#### APPLICATION FOR A CERTIFICATE OF APPROPRIATENESS – STAFF REPORT

083-18-CA 908 DOROTHEA DRIVE

Nature of Project: Rear addition; rear deck; relocate front door; reconfigure front façade;

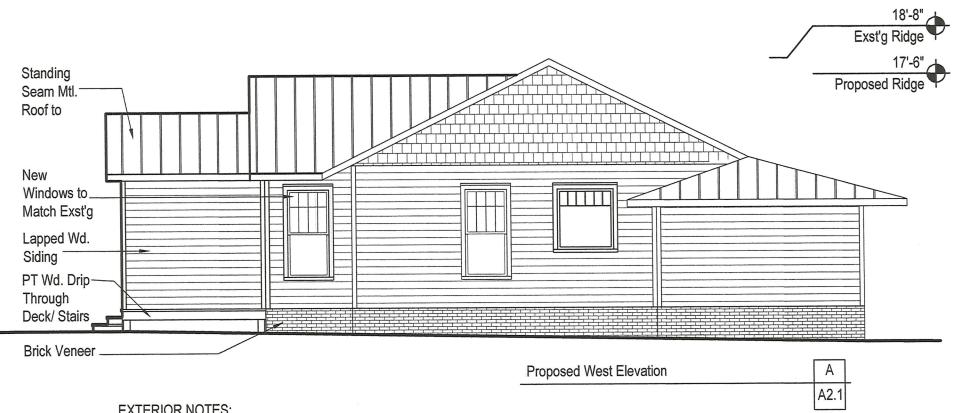
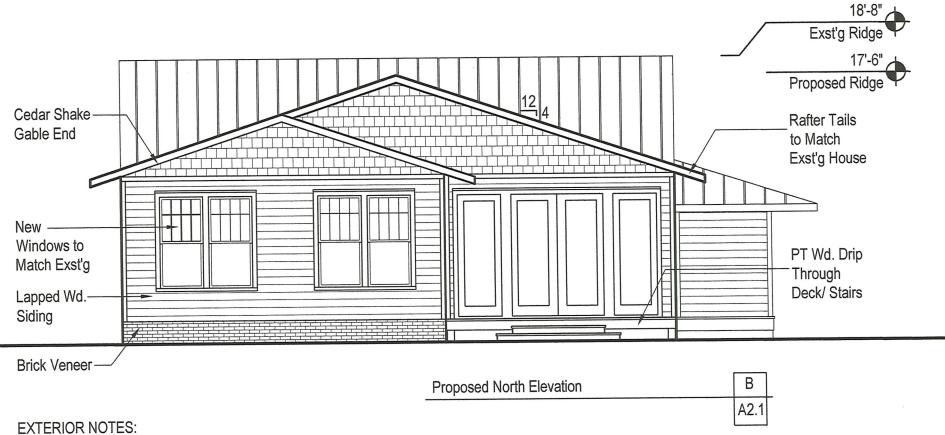
- 10\* The proposed addition and deck will increase the built mass by 27.3%.
- 11\* The proposed floorplan shows the installation of a window on the right most side of the west façade; however, this window does not appear on the elevation drawing A\A2.1.
